# CLAREMONT BUSINESS PARK 2 FILING NO. 2

### CONSTRUCTION PLANS

JULY 2023

**LOT 2 - SAND FILTER POND 3  
SITE PLAN  
SCALE 1"=6"**

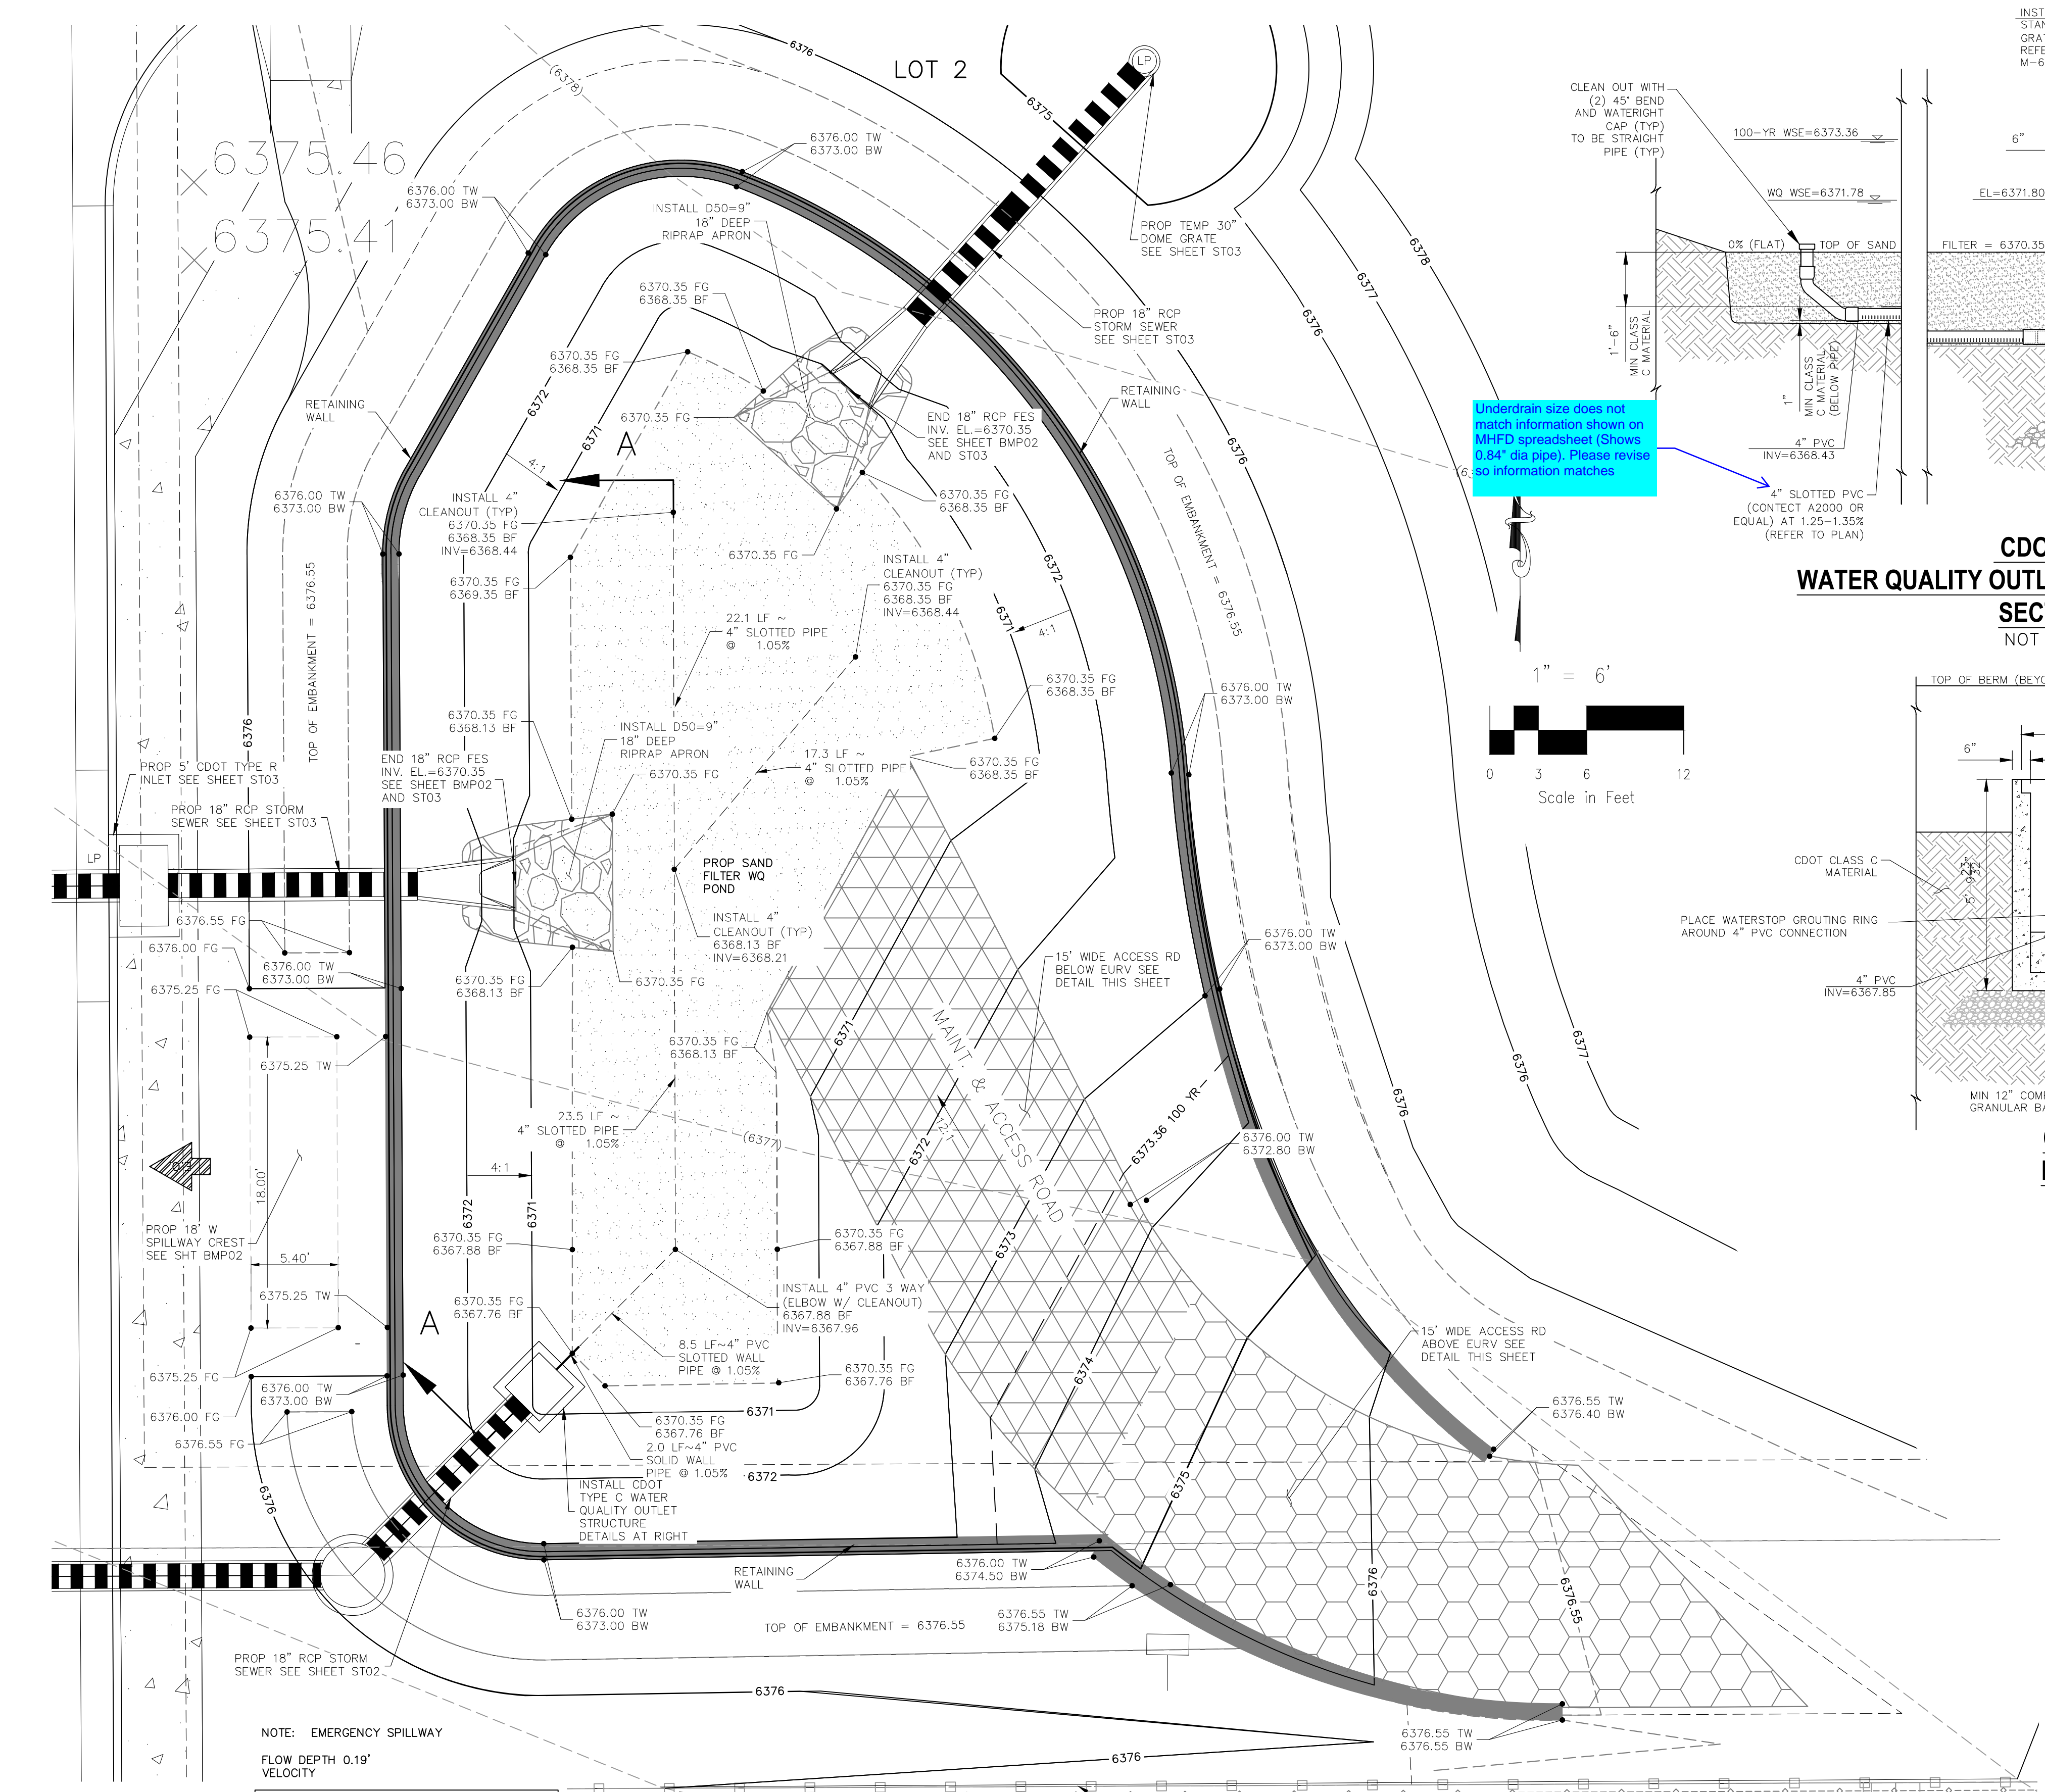
Underdrain size does not match information shown on MHFD spreadsheet (Shows 0.84" dia pipe). Please revise so information matches

**CDOT TYPE C WATER QUALITY OUTLET BOX AND SAND FILTER SECTION A-A NOT TO SCALE**

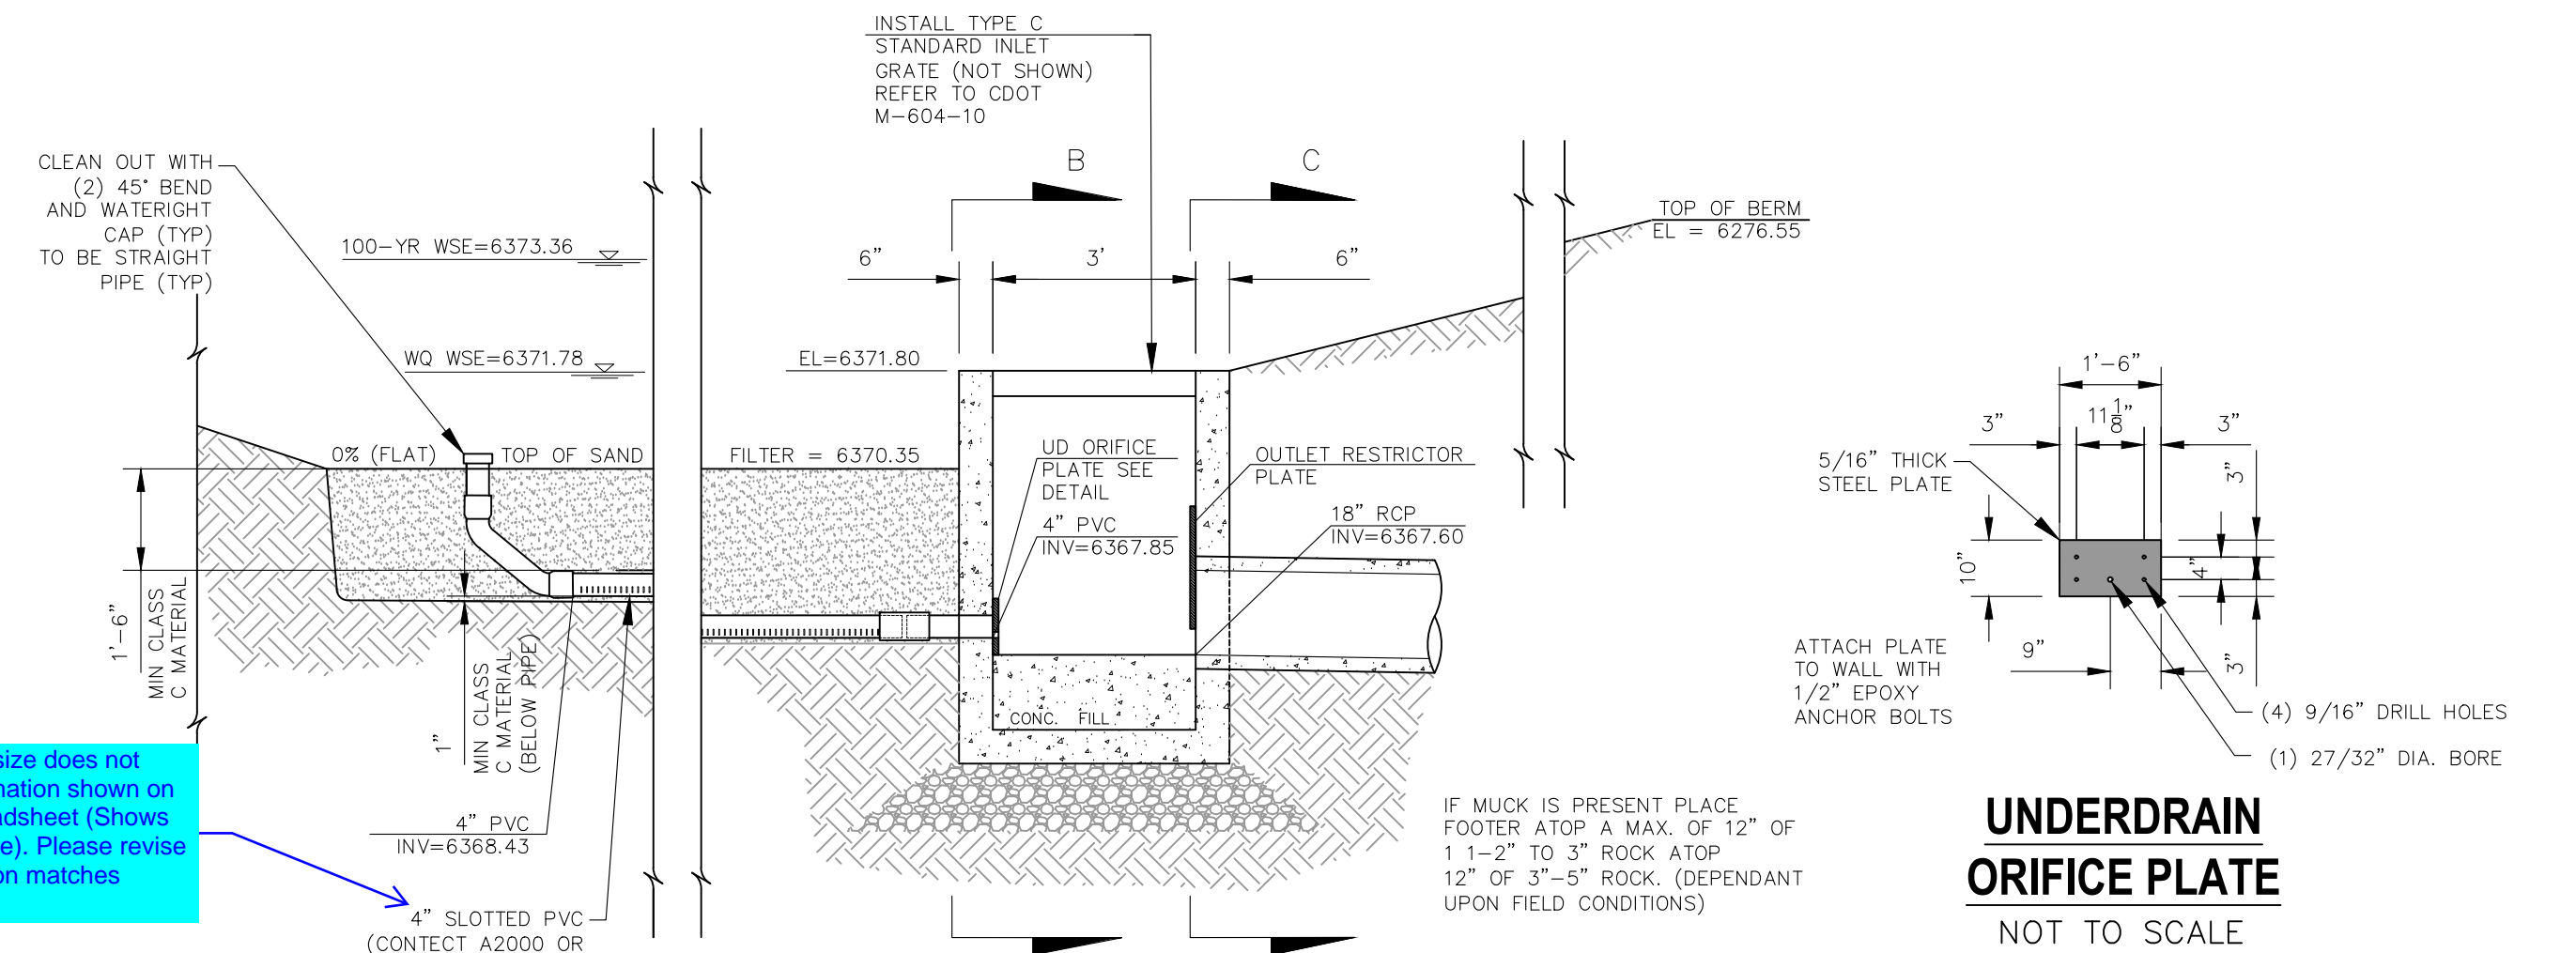
Unresolved: 100-YR WSE does not match other details or MHFD spreadsheet. Please update

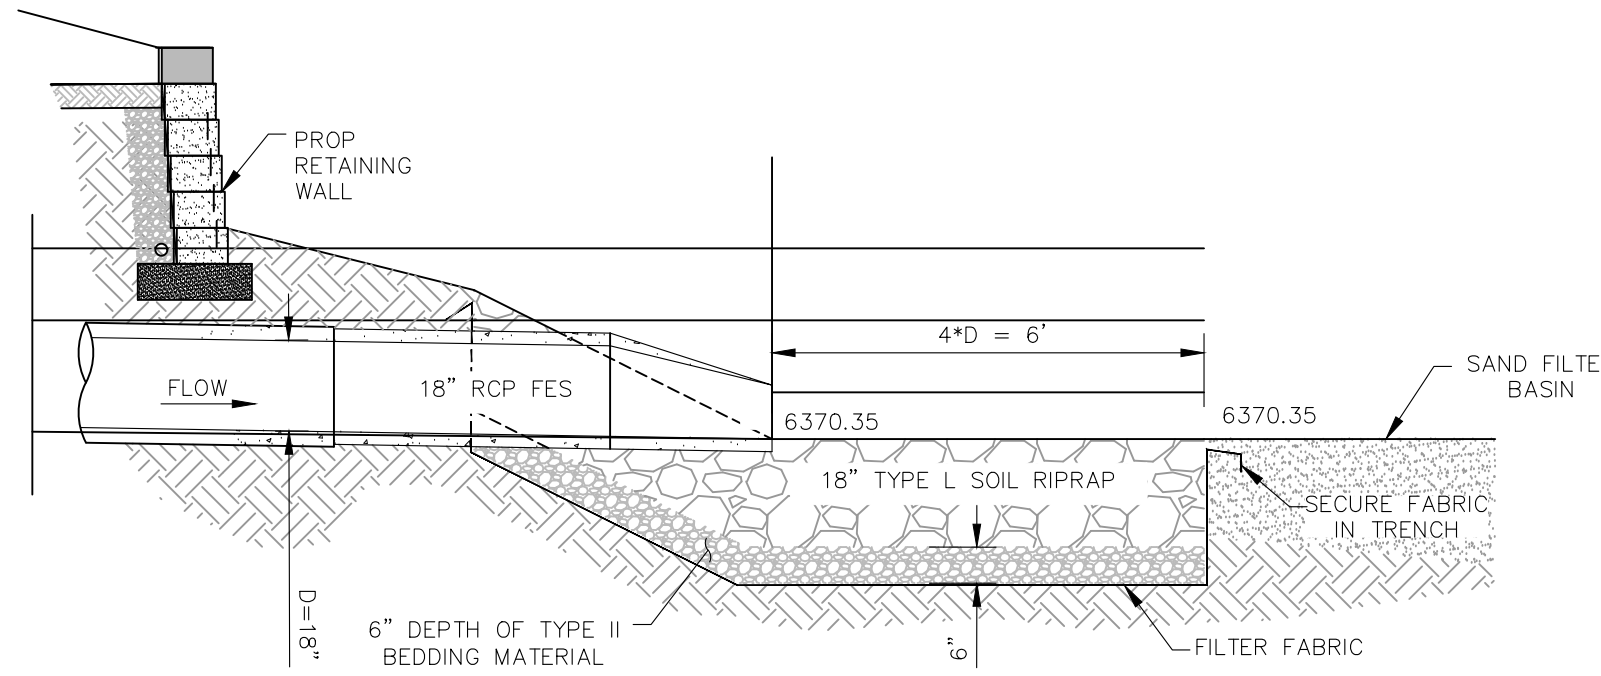
Revise to 6375.25 to match other details and MHFD spreadsheet

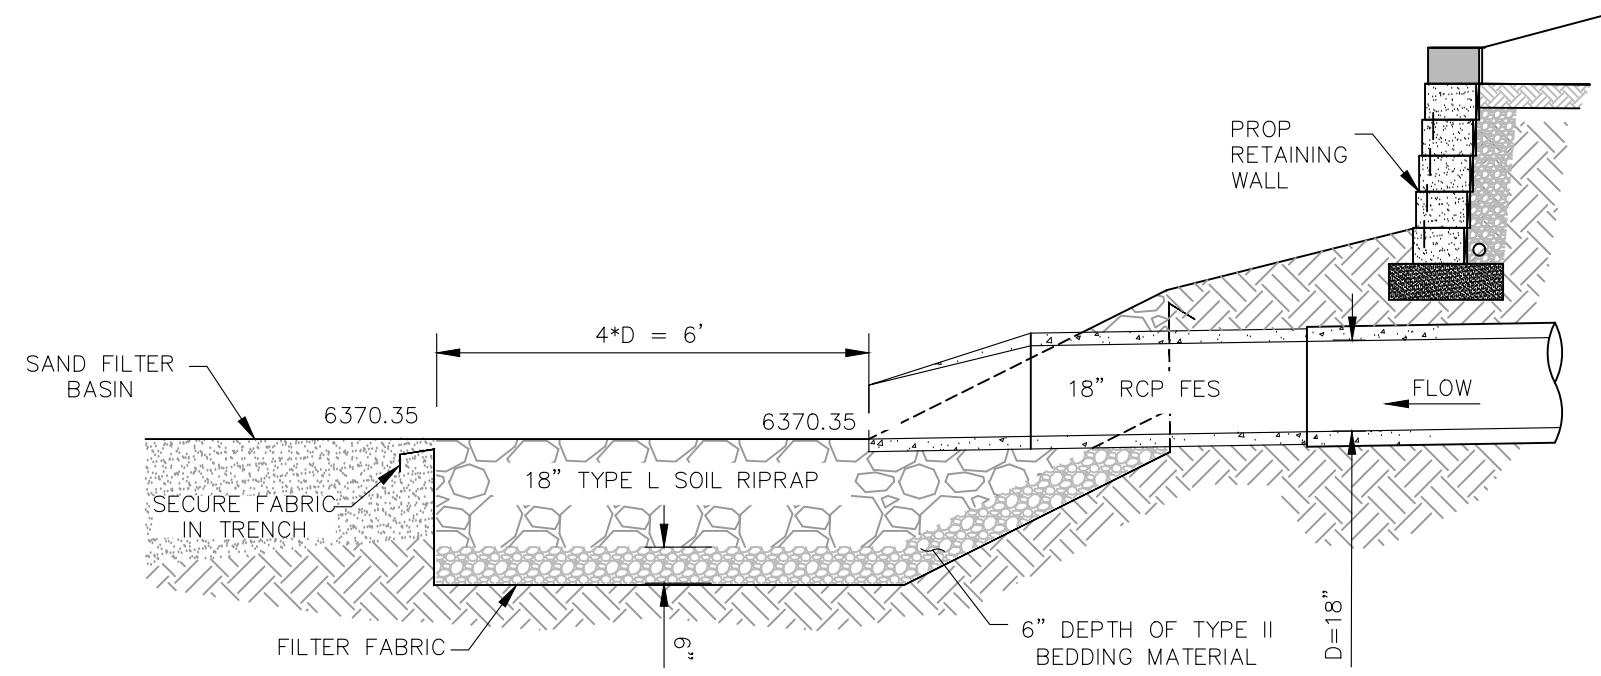
Revise to 6373.36 to match other details and MHFD spreadsheet
